## IDAP REPORT

<b>Property:</b>	24 Cecily Street BELFIELD DA 2020/164 Demolition of existing structures and construction of a two (2) storey dwelling with front fencing
<b>Proposal:</b>	
<b>Applicant:</b>	Princeton Piper Pty Ltd
<b>Owner:</b>	NJ Tartak
<b>Date of lodgement:</b>	16 September 2020
<b>Notification period:</b>	22 September 2020 to 6 October 2020
<b>Submissions received:</b>	Nil
<b>Assessment officer:</b>	D Strbac
<b>Estimated cost of works:</b>	\$996,080.00
<b>Zoning:</b>	R2-Low Density Residential - SLEP 2012
<b>Heritage:</b>	No
<b>Flood affected:</b>	No
<b>Is a Clause 4.6 Variation Proposed:</b>	No
<b>RECOMMENDATION OF OFFICER:</b>	<b>APPROVAL</b>

**Figure 4: Ground floor plan**

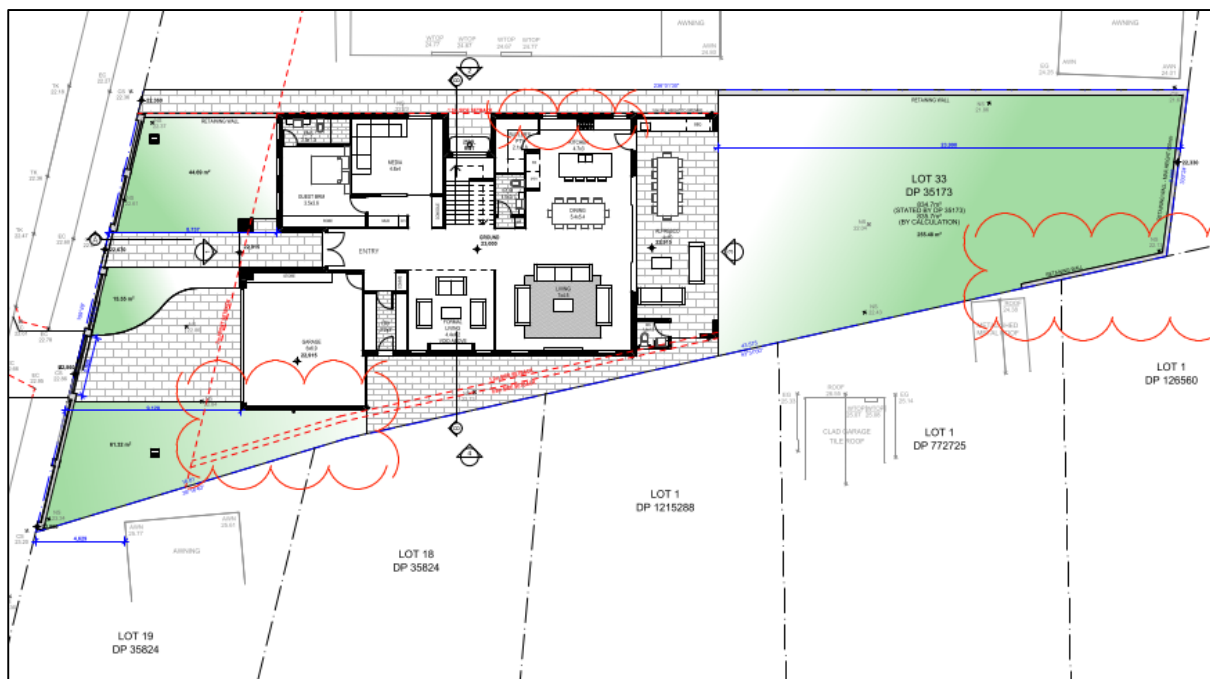
The application proposes a minimum side setback of 0.8m along the south-western side elevation, and a combined side setback of 12.2% (2m) which is not in accordance with the minimum DCP 1.2m setback requirement and combined total setback requirement of 25%. However, a merit based assessment is appropriate considering the irregular shape of the site. It is noted that the south-eastern side boundary of the site tapers inwards towards the rear, creating a rear lot width of 8.65m and a frontage width of 23.54m (Figure 4). The proposed staggered design of the dwelling at the south-east has been appropriately designed to suit the irregularity of the allotment (Figure 4). This staggered design is such that the south-eastern side setback ranges from 0.7m to 4m. It is also noted that the south-eastern side of the dwelling adjoins the rear of sites 91-99 Punchbowl Road and as such, the non-compliance is unlikely to result in any unreasonable overshadowing or visual privacy impacts to adjoining properties. Given the site attributes, the proposed side setbacks are considered acceptable.
